Office Action Summary	Application No. 10/566,262	Applicant(s) GOTO ET AL.	
	Examiner ANTHONY J. CALANDRA	Art Unit 1791

Detailed Office Action

Figure 10

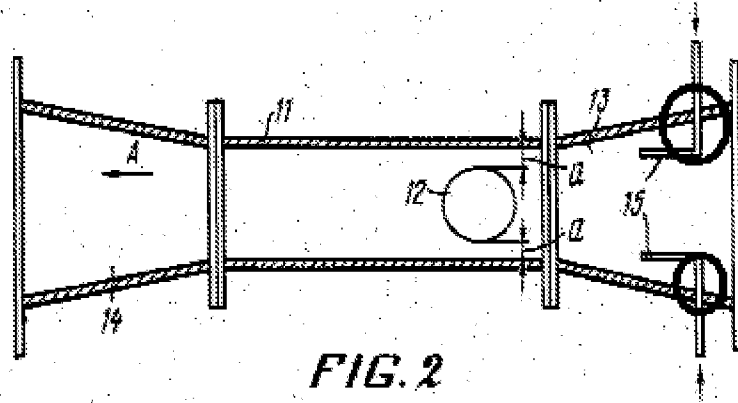
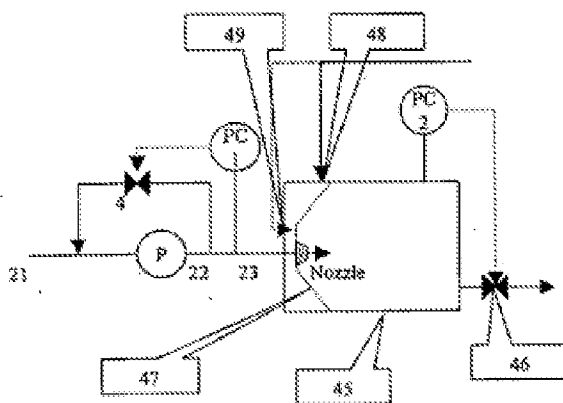
SOLOMONITSYN teaches a cylindrical member (12) [Figure 2]. As it is in the way of the flow it is a baffle, however it is cylindrical. The term plate is given the claim construction of "A smooth, flat, relatively thin, rigid body of uniform thickness". As (12) is cylindrical it cannot be considered a plate.

SOLOMONITSYN further shows in figure 2, the nozzle shown by opening 15. Forming the nozzle are 2 plates, circled below, located behind the nozzle outlet. This diagram matches up

favorably to Figure 10 of the instant application where there is a nozzle and a backing baffle plate located behind the nozzle (47).
